Liddell battery and Bayswater Ancillary Works Project
Environmental Impact Statement

Response to submissions

July 2021

AGL Macquarie Pty Limited

Legend

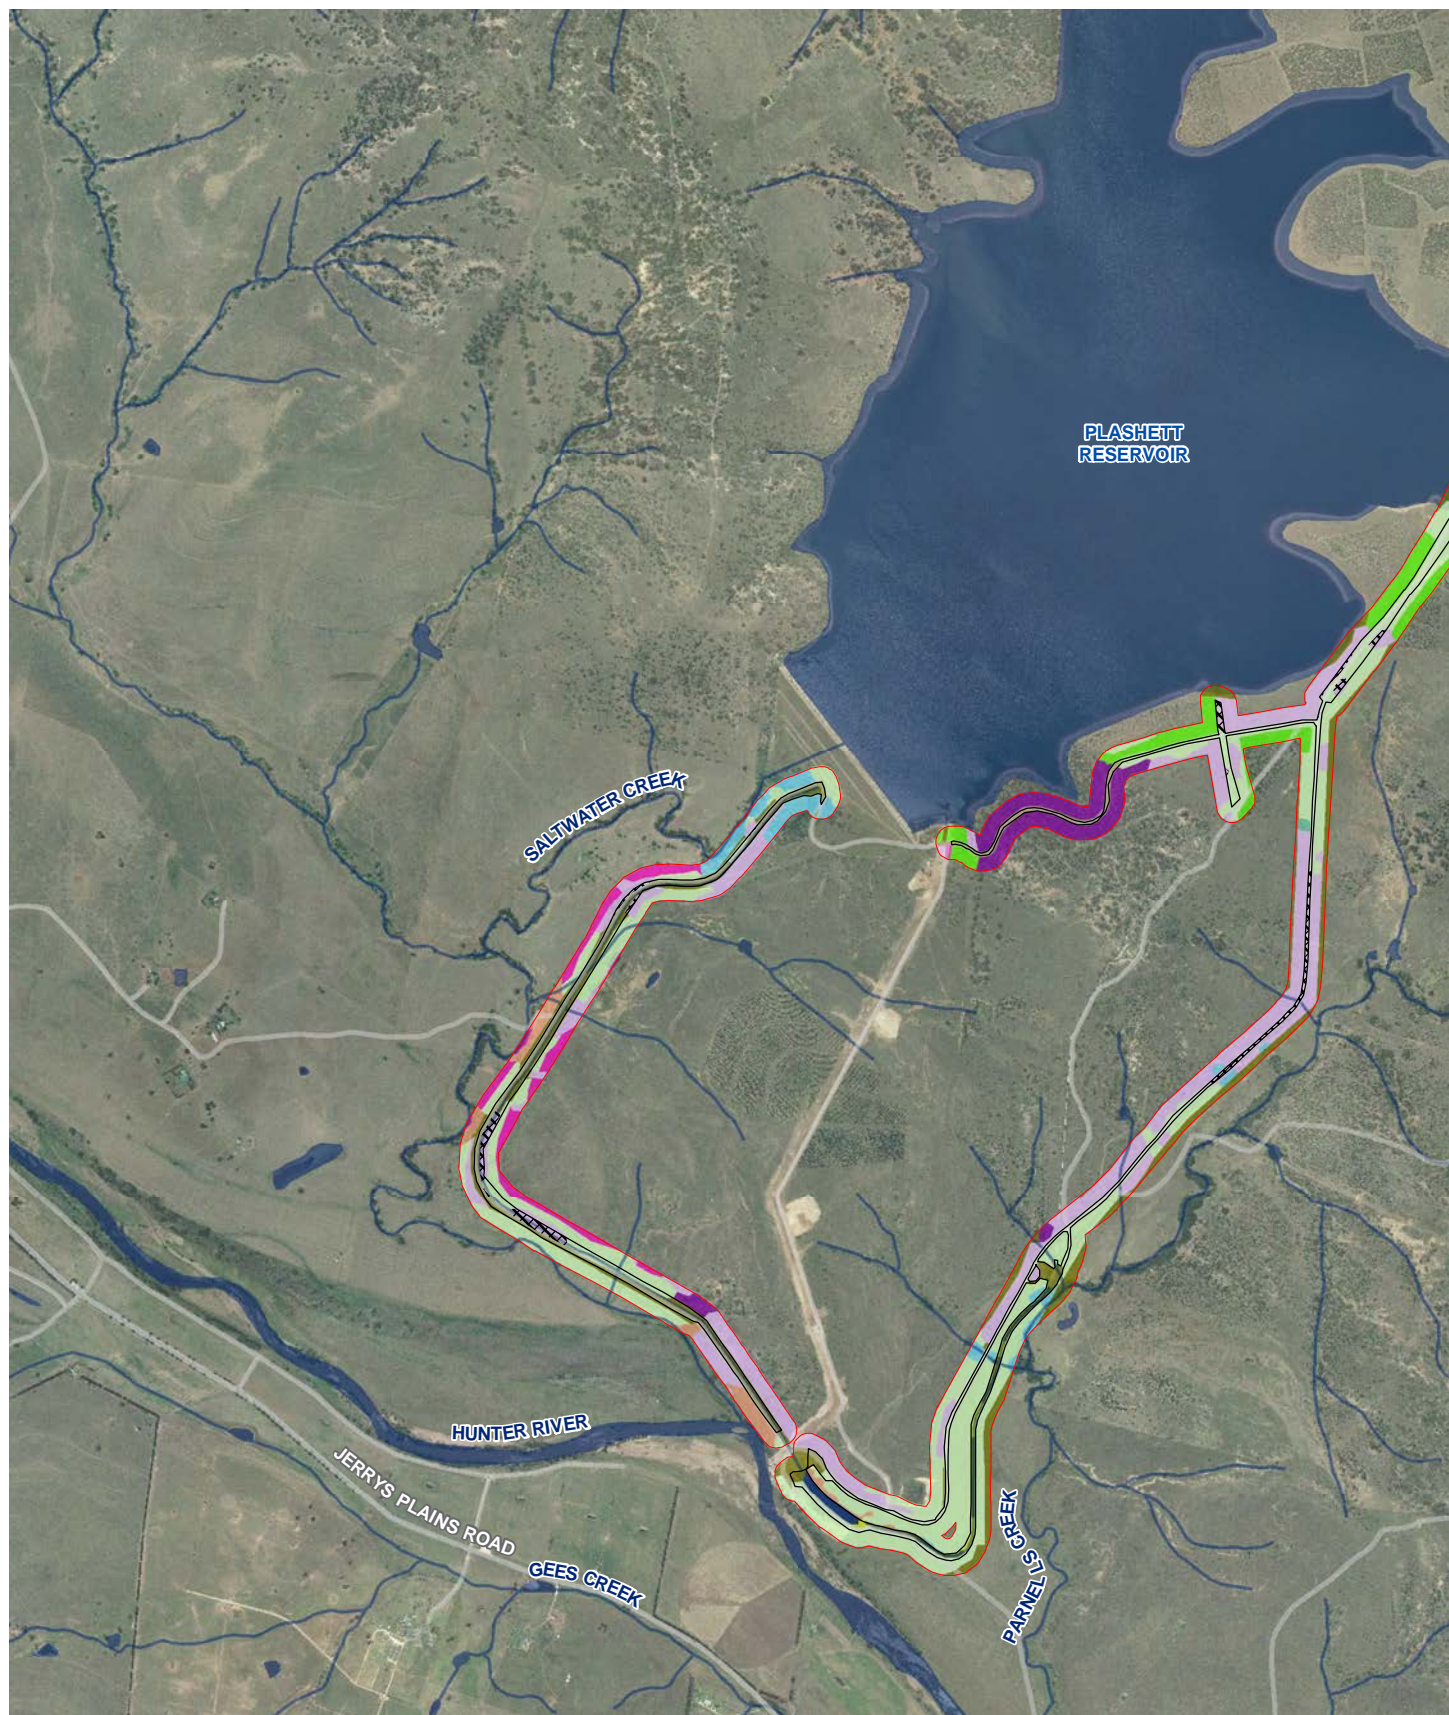
BCD Comment and recommendations	Applicant Response
Further justification should be provided for the exclusion of the Red Goshawk (<i>Erythrotriorchis radiatus</i>) from further assessment	The BDAR has been updated with further details on the Red Goshawk (<i>Erythrotriorchis radiatus</i>). The Red Goshawk has now been added to the BAM-C Candidate species list, refer to Section 4.3.2.2 .
A new version of Figure 6-1 'Threatened flora surveys' is prepared, at 1:1,000 scale, that clearly shows the location of targeted flora surveys, and the vegetation zones in which they were conducted	New figures have been prepared for the revised BDAR, refer to Appendix D . A 1:1000 scale figure would require about 150 pages. As such 1:1000 scale figure has not been generated. The figures have been updated so that they do provide clearer illustration of survey effort and vegetation zones. Geographic Information System (GIS) data has also been provided to BCD for their reference.

The habitat for the Striped Legless Lizard within the development site is considered to be low-quality given that much of the land was cleared for cattle grazing in the past and has been modified to accommodate power station infrastructure. Areas of native vegetation still exist as small and isolated patches and may provide potential habitat for this species, refer to **Figure 4-1**. The PCTs associated with the Striped Legless Lizard include:

As outlined above, the Striped Legless Lizard is known to inhabit the higher-quality woodland habitats to the west of the development site. As such this species could potentially disperse eastward across the development site on occasion, although habitats within this area are already isolated by significant infestations of exotic grasses, coupled with movement barriers such as roads, water canals and power station infrastructure. The ground surfaces of the development site have historically been modified and generally lack shelter features such as rocks, logs, wood debris and native tussock grasses. Future detailed design would further retain vegetation within the development site and the Project is unlikely to exacerbate barriers to dispersal for the Striped Legless Lizard.

Photo 4-1: Planted Weeping Myall trees display features associated with the inland form of this species including a strongly pendulous habit (branches), abundance of fruit, and absence of suckering stems

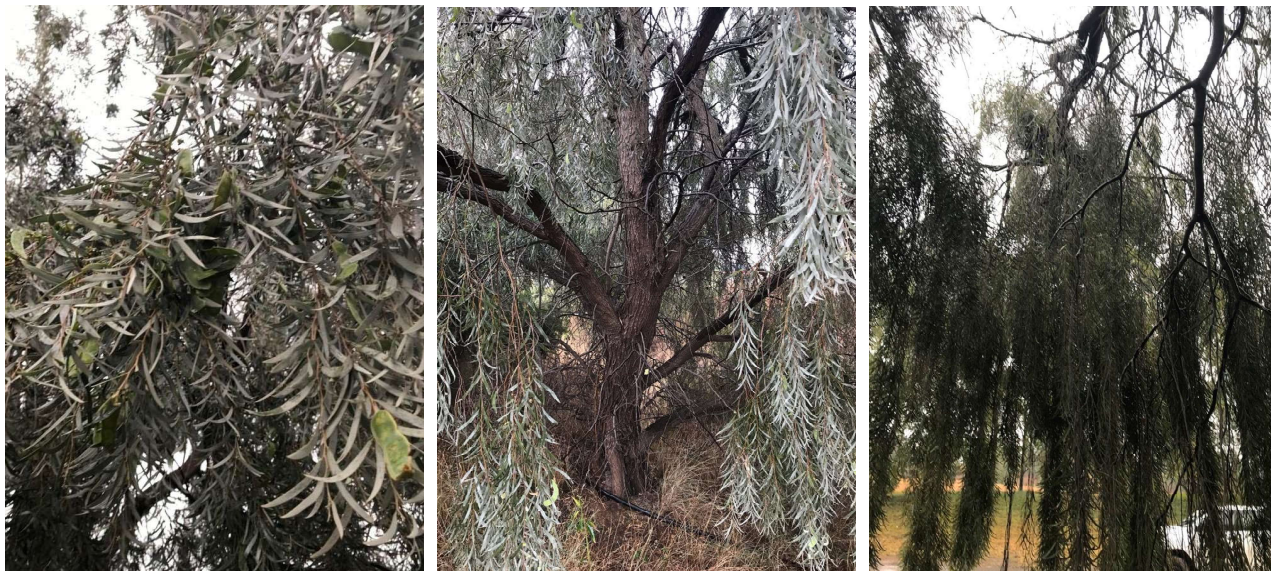
The BDAR should describe the habit, and the ability to develop seeds and suckers of the planted <i>Acacia pendula</i> (Weeping Myall) plants and state whether they are of the indigenous Hunter Valley form or the inland form of the species	The description of the planted specimens of <i>Acacia pendula</i> (Weeping Myall) has been updated to better describe the habit and reproductive characteristics observed, refer to Appendix D . The planted <i>Acacia Pendula</i> (Weeping Myall) is not considered to be of the indigenous Hunter Valley form, refer to Section 4.3.2.3 .
There is text currently obscured by the photo on page 53 of the BDAR	This formatting issue was corrected in the final version of the BDAR that was placed on public display correcting the pre-exhibition version supplied to BCD as part of DPIE adequacy process.
Provide details to meet the requirements of Table 25 of the BAM	The BDAR has been updated to be compliant with Table 25 of the BAM, refer to Appendix J of the BDAR (Appendix D). This has included updating all of the mitigation measures to describe staging, outcomes and responsibility of impact mitigation measures, refer to Section 11 of the BDAR and Appendix B .

The *Acacia pendula* trees display obvious characteristics of the inland form of this species including a strongly pendulous habit (branches), abundance of seed capsules, and absence of suckering stems (unlike the Hunter Valley form which often lacks pendulous habit, has seed generation deficiencies and often suckers from roots).

The *Acacia pendula* within the development site are not a naturally occurring population and would likely be genetically dissimilar to the naturally occurring Hunter Valley populations. As shown in **Photo 4-1**, the planted *Acacia pendula* trees display obvious characteristics of the inland form of this species including a strongly pendulous habit (branches), abundance of seed capsules, and absence of suckering stems (unlike the Hunter Valley form which often lacks pendulous habit, has deficient seed generation and often suckers from roots). The abundance of seed recorded on these trees indicates that they are not of the naturally occurring Hunter Valley form, which is renowned for being unable to generate fruit, and instead reproduces through suckering. These planted individuals do not constitute the *Acacia pendula* population in the Hunter Catchment - Endangered Population.

Figure 4 -2 Impacts requiring offsets and impacts not requiring offsets

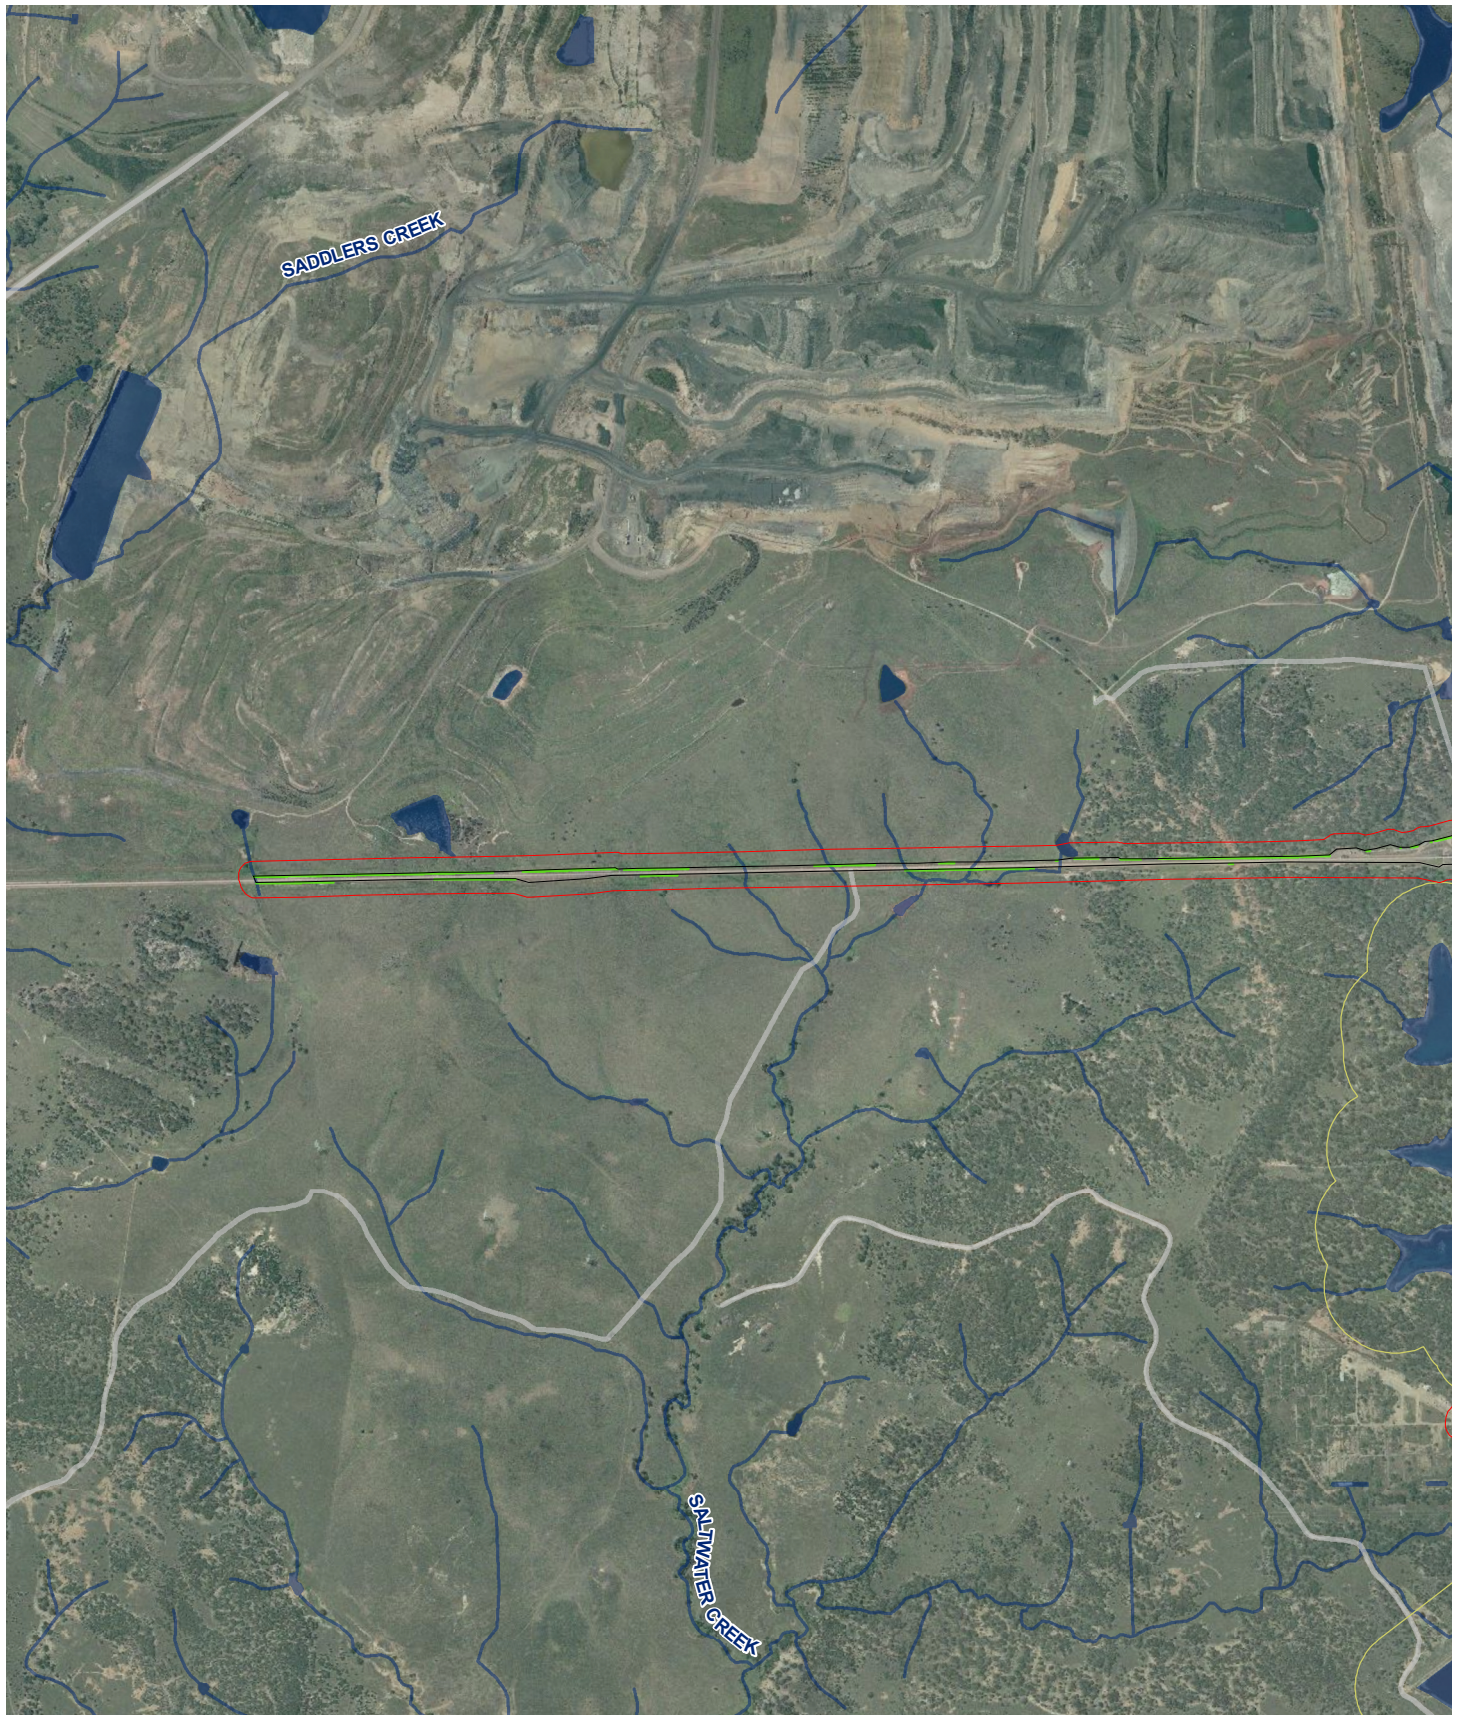
BCD Comment and recommendations	Applicant Response
The Biodiversity Assessment Method (BAM) accredited assessor certifies that the BDAR was finalised within 14 days of the exhibition of the EIS	Prior to exhibition, the EIS and technical assessments including the BDAR were provided to DPIE (including BCD) for adequacy review. The BDAR was subsequently updated to include a certification statement (located before the table of contents and dated within 14 days of exhibition) prior to exhibition.
The BDAR should describe how the survey effort for the striped legless lizard (<i>Delma impar</i>) meets the Survey Guidelines for Australia's Threatened Reptiles (Department of Agriculture, Water and the Environment, 2011)	As required by the BAM, and on the basis that the survey effort cannot demonstrate beyond reasonable doubt the absence of the species within the development site, the revised BDAR assumes presence within applicable plant community types (PCTs) and includes an amended species polygon and associated credit obligations unless otherwise agreed. The striped legless lizard is further discussed in Section 4.3.2.1 .

accommodate for this an amount of credits are grouped as 'unlikely' (ie. it is unlikely that these credits would be required to be offset). Areas unlikely to be impacted are identified in **Figure 4-2** and credits within these areas are calculated as presented in brackets in **Table 4-6**.
